DEPARTMENT OF ENVIRONMENTAL PROTECTION
BUREAU OF REMEDIATION AND WASTE MANAGEMENT

M E M O R A N D U M

DATE: April 1, 2016

RE: Response to Department Staff's Review Comments on the
Juniper Ridge Landfill Expansion Application,
MEDEP #S-020700-WD-BI-N, Transmittal Letter
Exhibit B - BGS and NEWSME'S Response to DEP's
January 15, 2016 Technical Review Memorandum,
March 2016

JUNIPER RIDGE LANDFILL EXPANSION
 PHASE I AND II EXPLORATIONS AND MONITORING WELLS
 DEP - FIGURE 1

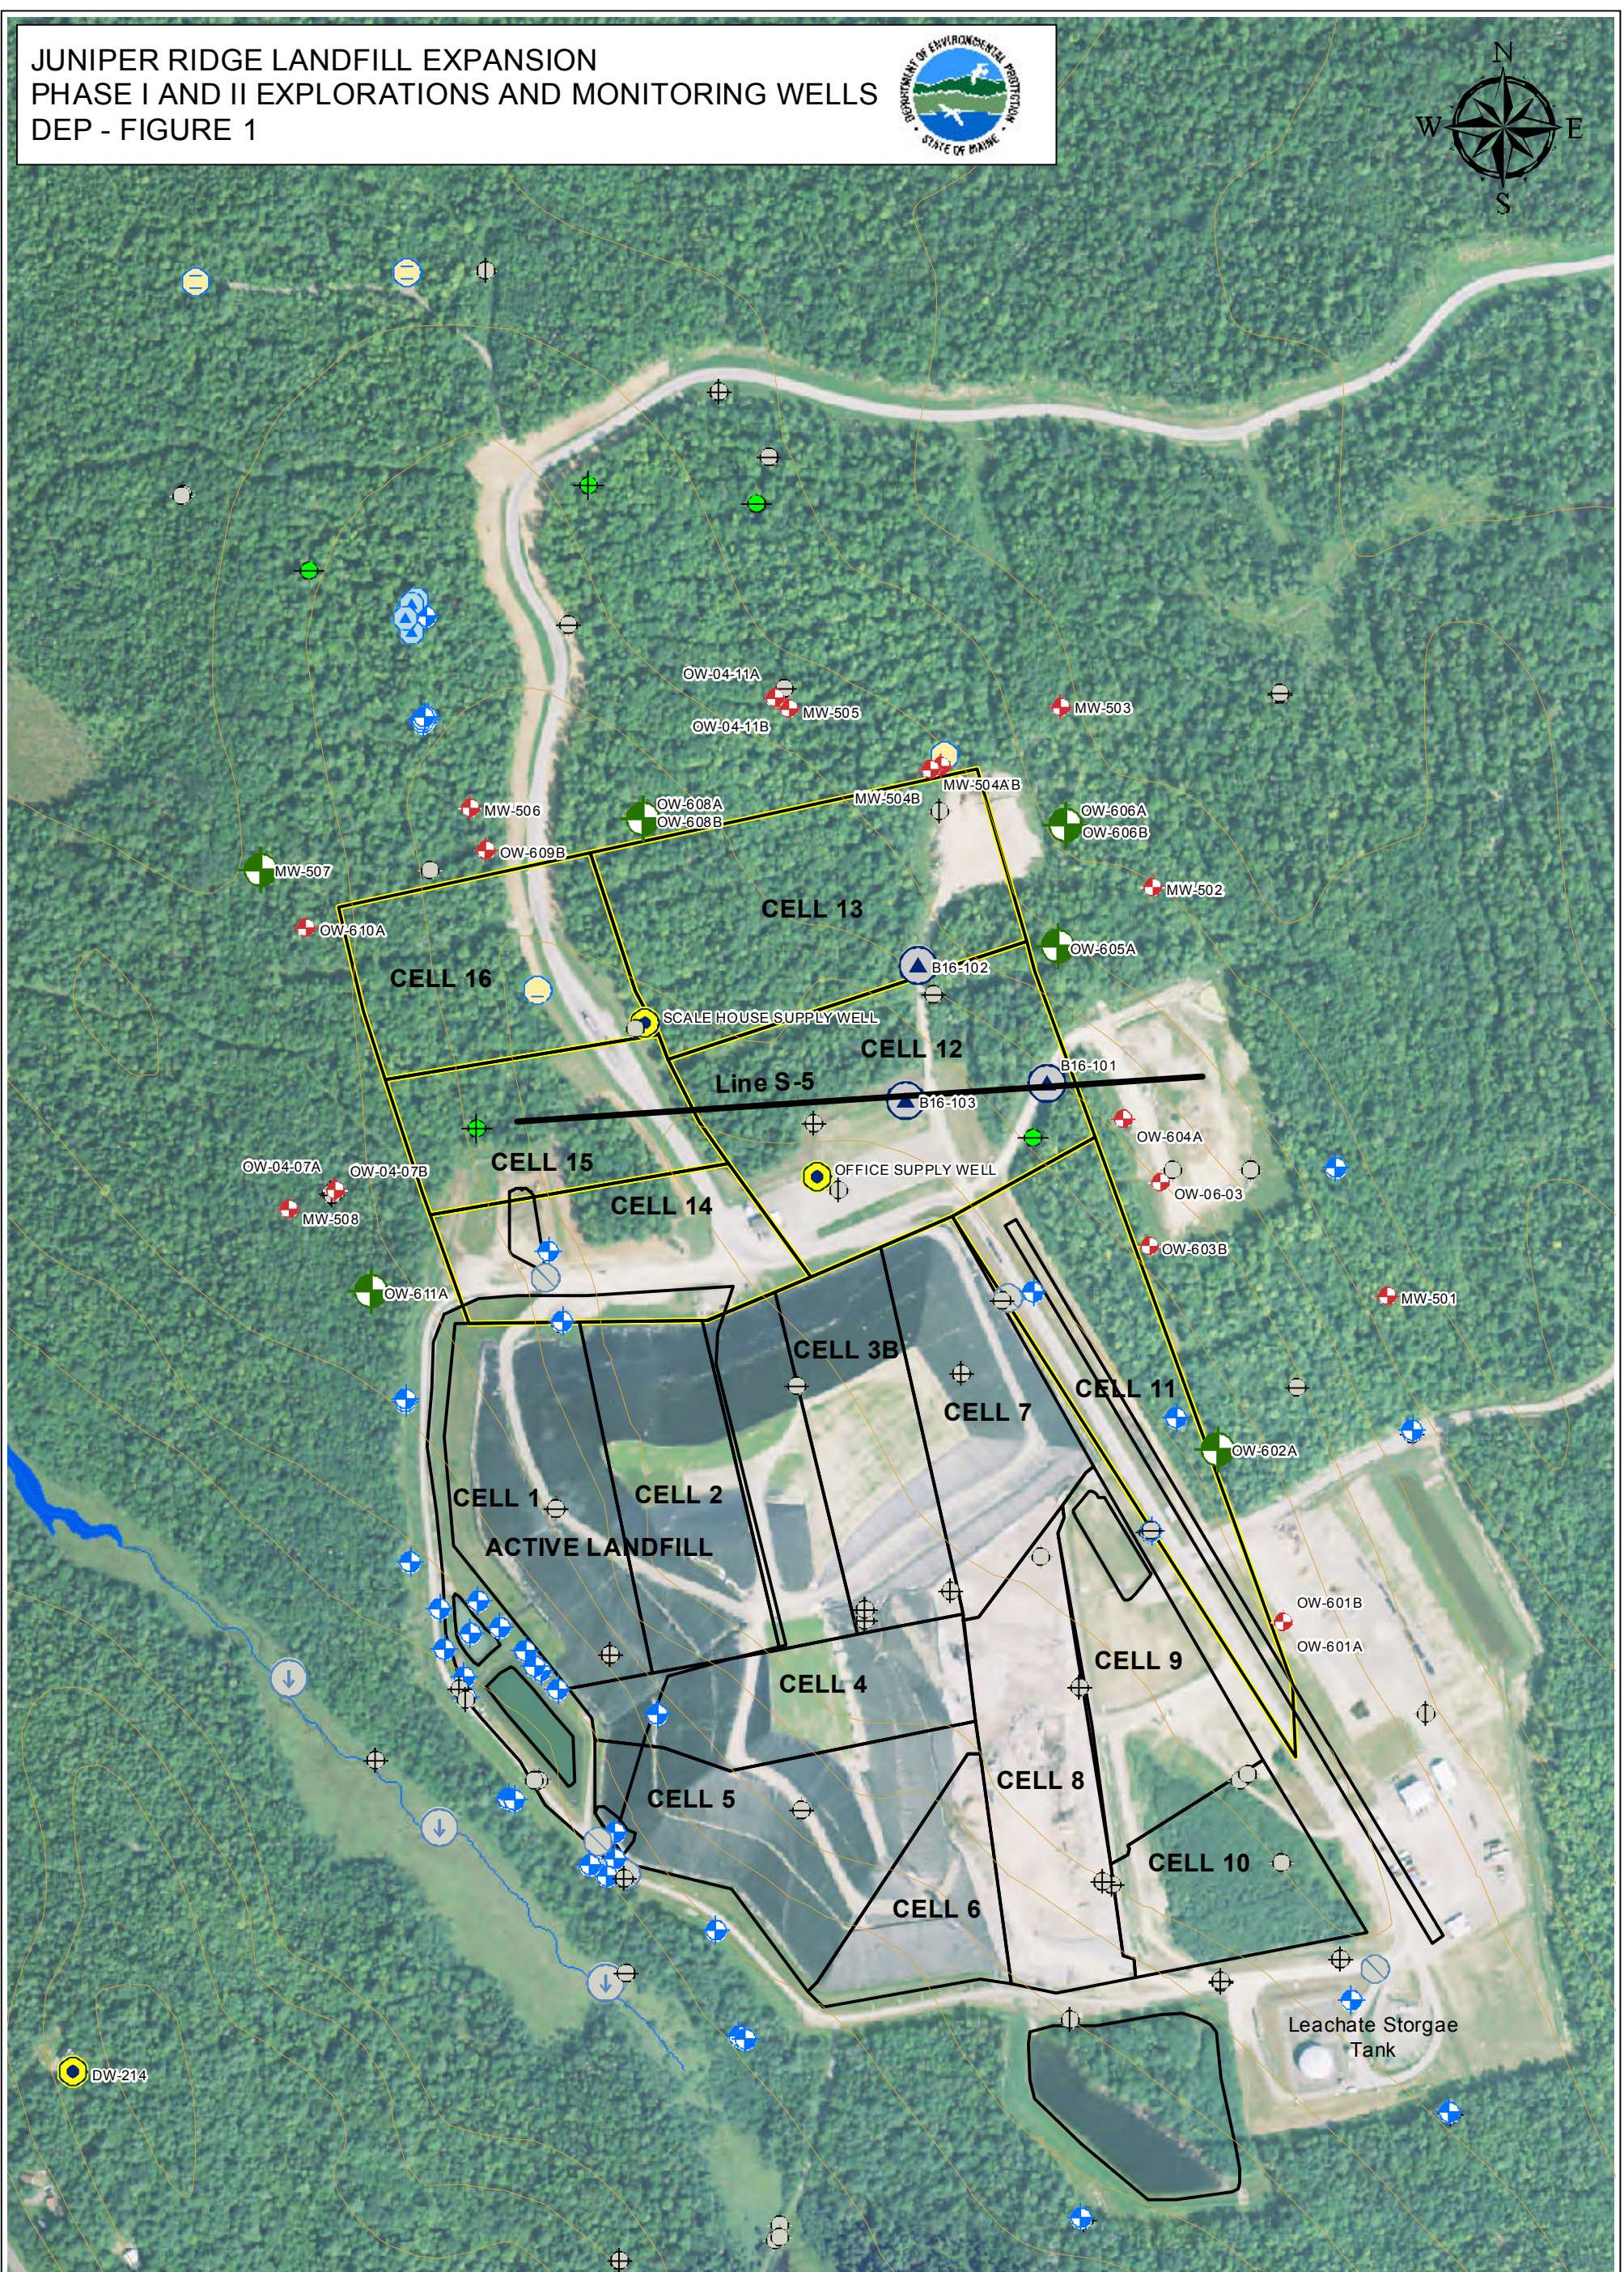
Task 5 - Electrical Earth Resistivity To help locate the bedrock explorations completed in support of the proposed expansion, JRL previously completed ten earth resistivity lines. In recognition of the utility of the method, the current work plan includes four additional geophysical lines (SME - Figure 1). To significantly improve the current proposal, I recommend one additional geophysical line. Line S-5 should be positioned roughly parallel with Line S-1 and about 250 feet due south such that it passes through two of the proposed bedrock explorations (B16-101 and B16-102). The approximate location of the proposed additional line is shown on DEP-Figure 1.

The text states Line S-3 will be located along the east side of the expansion and pass through Phase I borings. The location as depicted on SME - Figure 1 does not pass through any of the three proposed bedrock borings. SME provided the attached clarification to this discrepancy (Attachment A). The fourth line (Line S-4) will be located within the proposed expansion and according to the location depicted on SME Figure 1 its oriented northwest-southeast not north-south as described in the text. This discrepancy requires clarification.

As shown on SME Figure 1, Line S-4 will pass through the Scale House Well and the Office Supply Well. Will the existence of the steel well casings produce anomalous 2-D resistivity results?

The second paragraph of this section states, "...up to 9 individual monitoring wells and 16 individual expansion observation wells are anticipated." I have been unable to reconcile this description with the number of monitoring and observation wells depicted on SME Figure 1. I understand the Environmental Monitoring Plan for the proposed expansion includes a combination of wells designated with the prefix "MW" for monitoring wells and "OW" for observation wells. The inconsistency may arise, in part, from the nomenclature and symbology used on SME Figure 1.
